PROJECT:	Auburn Park Full Build-Out Montgomery County, VA Parks and Recreation
GNI Job No.:	2893.00
DATE:	Monday, March 11, 2024

END ADDENDUM NO. 3

CO-02 GENERAL NOTES

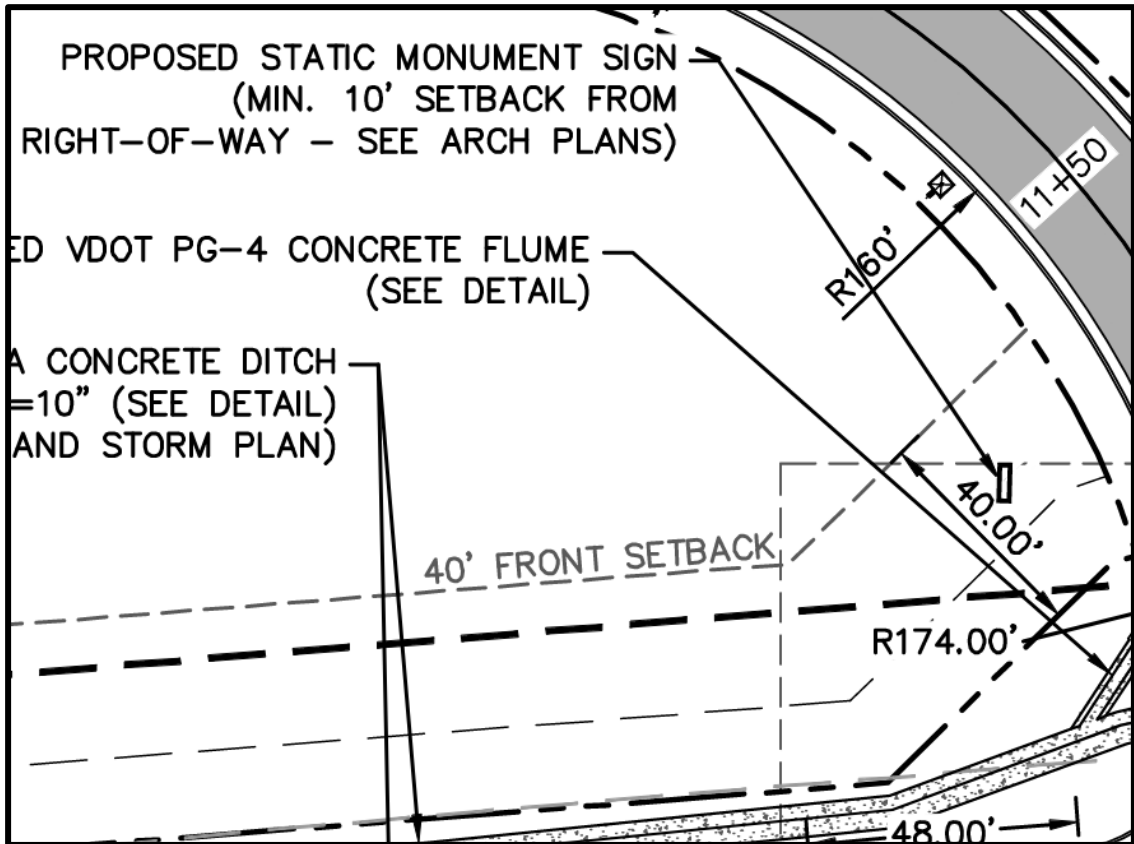
REMOVE AND REPLACE Note #4 under the “GENERAL ESC, GRADING & DRAINAGE NOTES” to now read as follows:

“4. ALL COMPACTION REQUIREMENTS SHALL BE CONDUCTED IN ACCORDANCE WITH THE PROJECT SPECIFICATIONS. ANY WORK SUBJECT TO VDOT INSPECTION SHALL BE CONDUCTED IN ACCORDANCE WITH VDOT SPECIFICATIONS.”

C2-02 SITE LAYOUT AND DIMENSIONAL PLAN

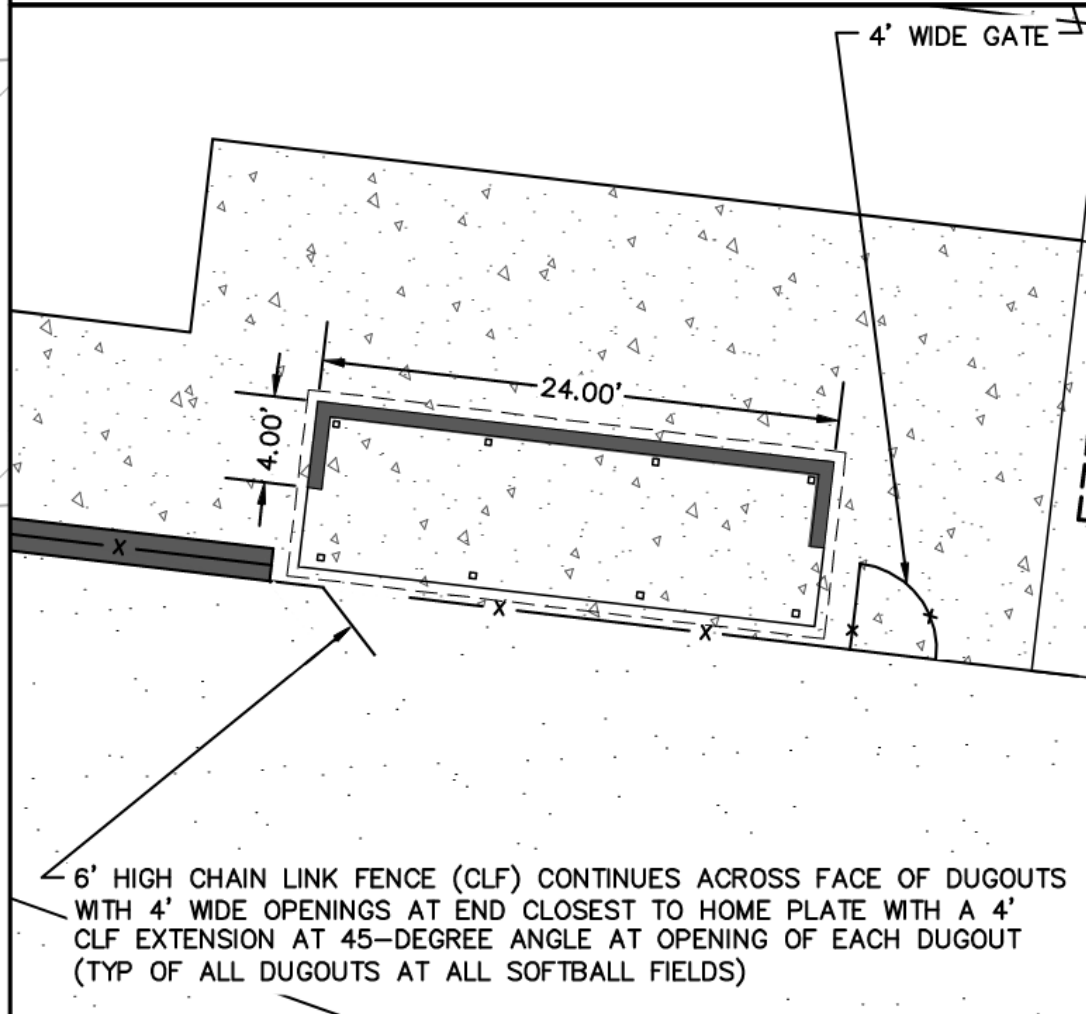
REVISE orientation of PROPOSED STATIC MONUMENT SIGN to be perpendicular to Riner Road (Route 8) so sign is visible from both travel directions as shown in the revision below.

ADD a pole-mounted green street name sign per VDOT standard sign designation D3-1, 1a directly to the North of the proposed '25 MPH SPEED LIMIT' sign at the entrance to the site. Contractor shall coordinate with Owner on street name prior to manufacturing.

REVISE DUGOUT INSET per the revision shown below to align the proposed 45-degree fence opening with the far-left dugout column.

C2-03 SITE LAYOUT AND DIMENSIONAL PLAN

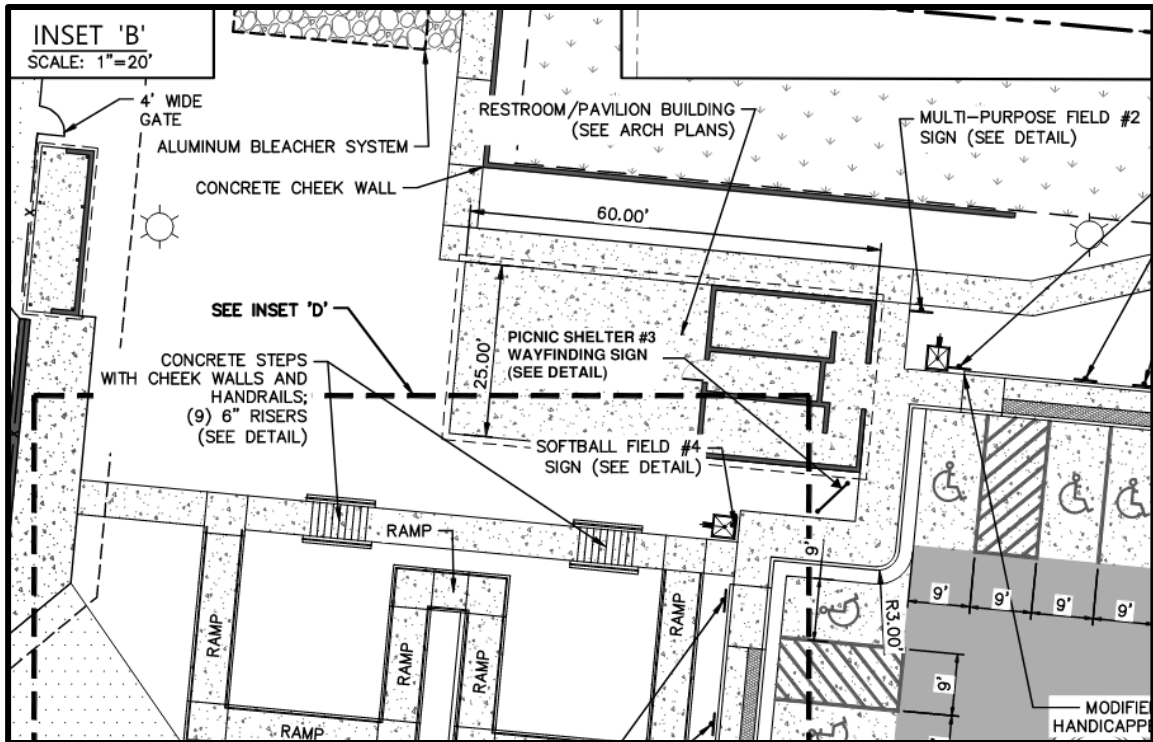
REVISE call-out note that currently reads "CONCRETE PAD WITH ALUMINUM BLEACHER STAND SYSTEM" to now correctly read as "**CONCRETE PAD WITH GRANDSTAND SEATING SYSTEM**"; there is one such call-out note on this sheet referring to a concrete pad for Softball Field #2. This is the same pad referenced in the above addendum item for sheet C2-02, but it also appears on sheet C2-03.

REVISE call-out note that currently reads "ALUMINUM BLEACHER STAND SYSTEM INSTALLED ON PIERS ON EXISTING SLOPE" to now correctly read as "**PERMANENT I-BEAM STYLE GRANDSTAND ON CONCRETE PIERS OVER SLOPE; PROVIDE MIN. OF 200 SEATING CAPACITY**"; there is one such call-out note on this sheet referring to a grandstand system located on the slope between Multi-Purpose Field #2 and Softball Field #4.

ADD PICNIC SHELTER #3 WAYFINDING SIGN in in Southeast corner of shelter location as shown below:

C2-04 SITE LAYOUT AND DIMENSIONAL PLAN

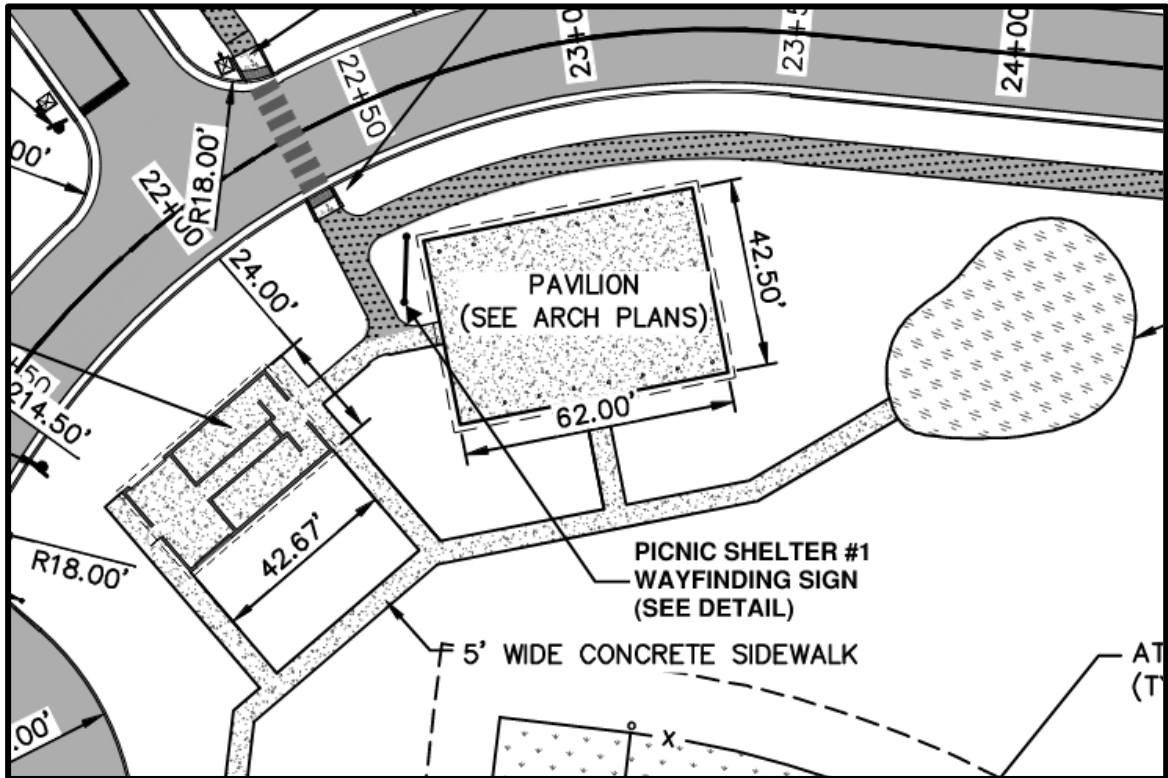
REVISE call-out note that currently reads “CONCRETE PAD WITH ALUMINUM BLEACHER STAND SYSTEM” to now correctly read as “**CONCRETE PAD WITH GRANDSTAND SEATING SYSTEM**”; there is one such call-out note on this sheet referring to a concrete pad for Softball Field #2. This is the same pad referenced in the above addendum item for sheet C2-02 and C2-03, but it also appears on sheet C2-04.

ADD call-out note to read as **“PERMANENT I-BEAM STYLE GRANDSTAND ON CONCRETE PIERS OVER SLOPE; PROVIDE MIN. OF 200 SEATING CAPACITY”** and point to the gravel, rectangular area on the slope adjacent to the driveway (near station 25+00) and overlooking Softball Field #3.

REVISE call-out note that currently reads **“10’ HIGH X 132’ LONG BALL-CATCH FENCE SYSTEM ALONG CENTERLINE OF 8” FLUSH CURB”** to read as follows:
“KWIK GOAL 14’ HIGH X 65’ LONG MULTI-SPORT BACKSTOP NETTING SYSTEM BY ANTHEM SPORTS (OR APPROVED EQUAL) CENTERED BEHIND GOAL.”

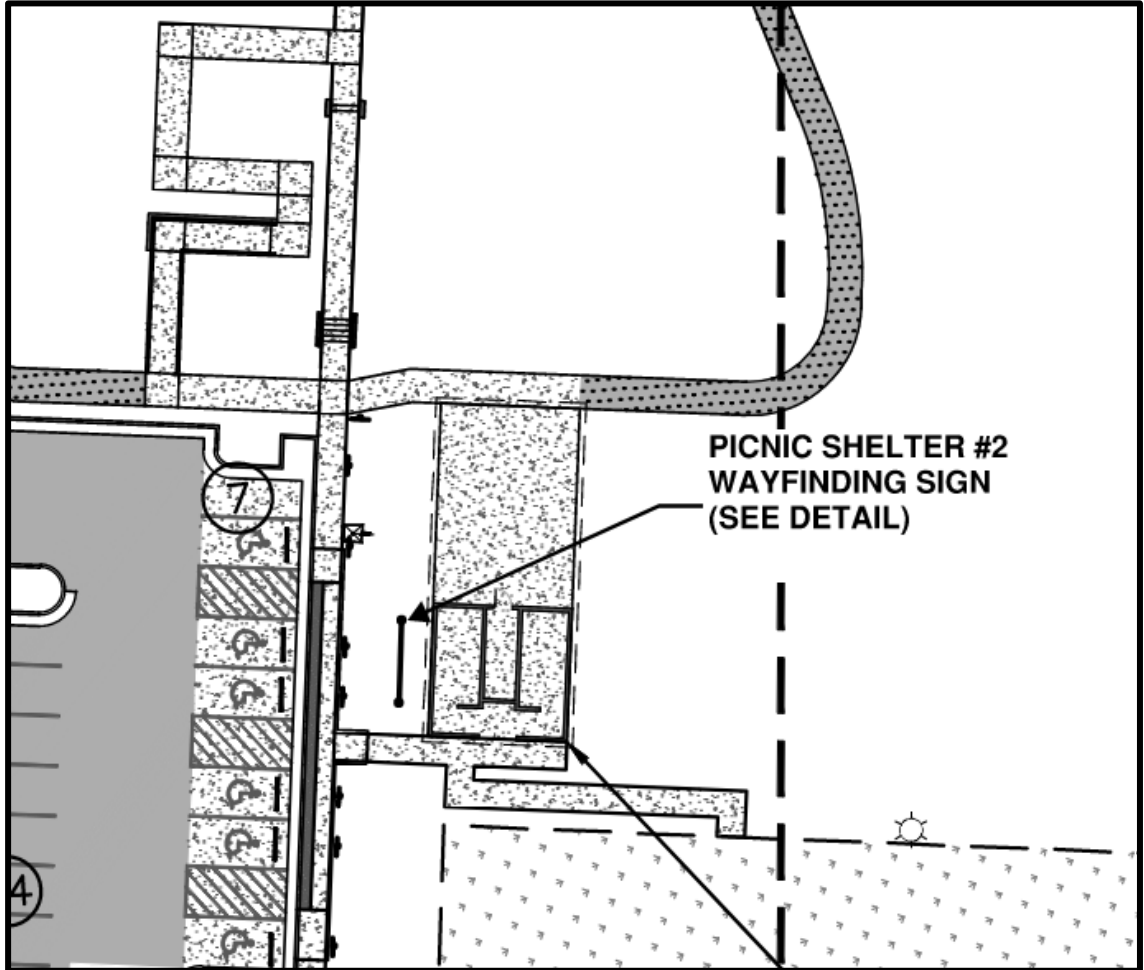
ADD PICNIC SHELTER #1 WAYFINDING SIGN in in Northwest corner of shelter location as shown below:

ADD PICNIC SHELTER #2 WAYFINDING SIGN in in Southwest corner of shelter location as shown below:

C2-08 BULLPEN DETAIL

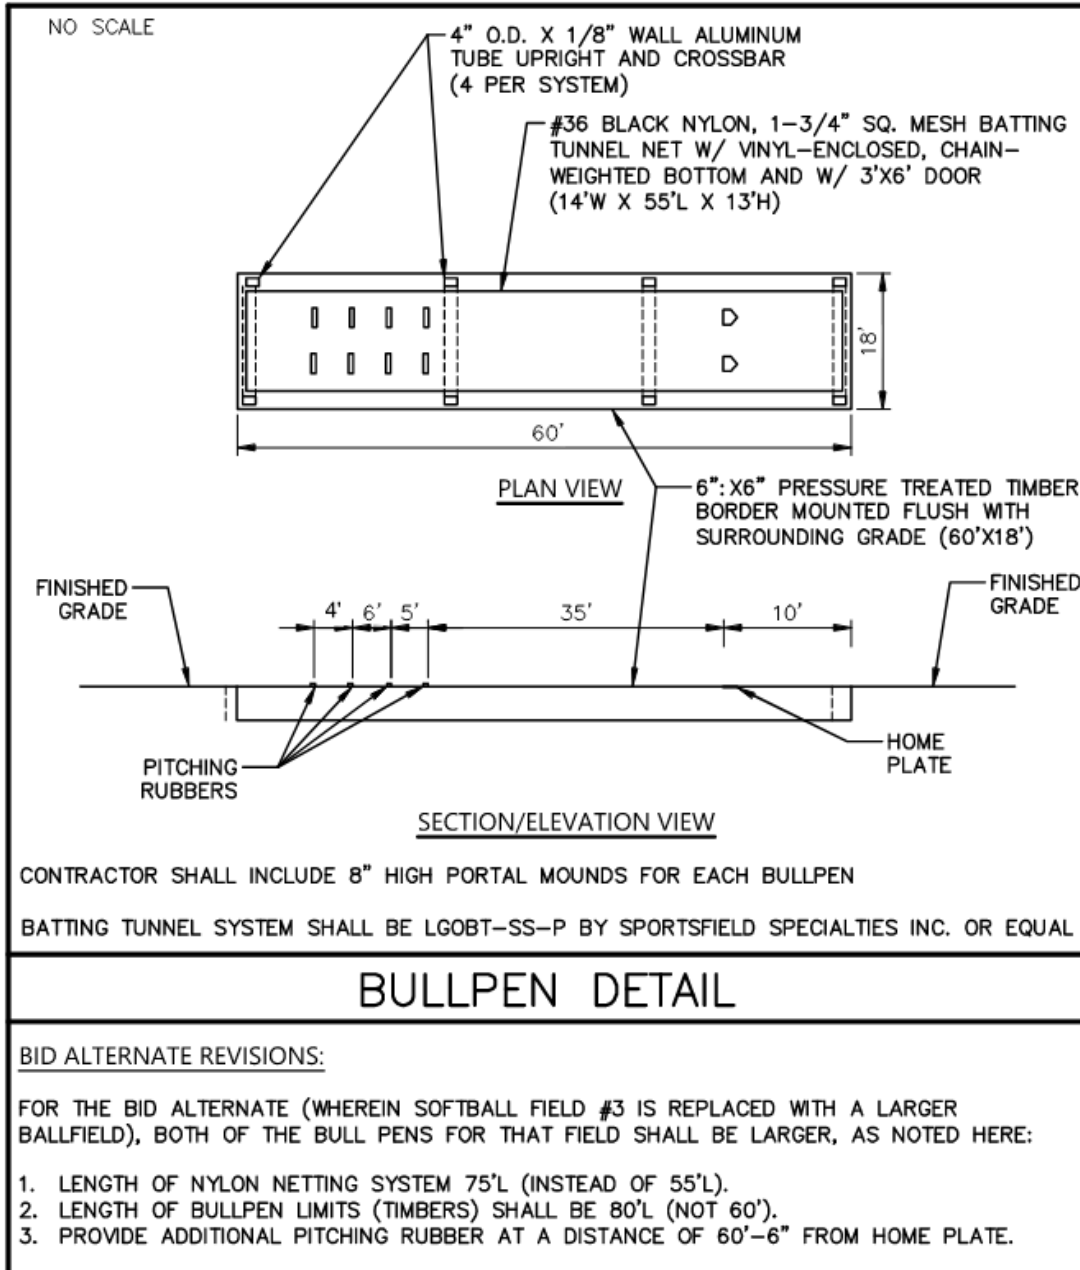
REVISE bullpen detail to have pitching rubbers at 35', 40', 46' and 50' from home plate as shown in the revision below.
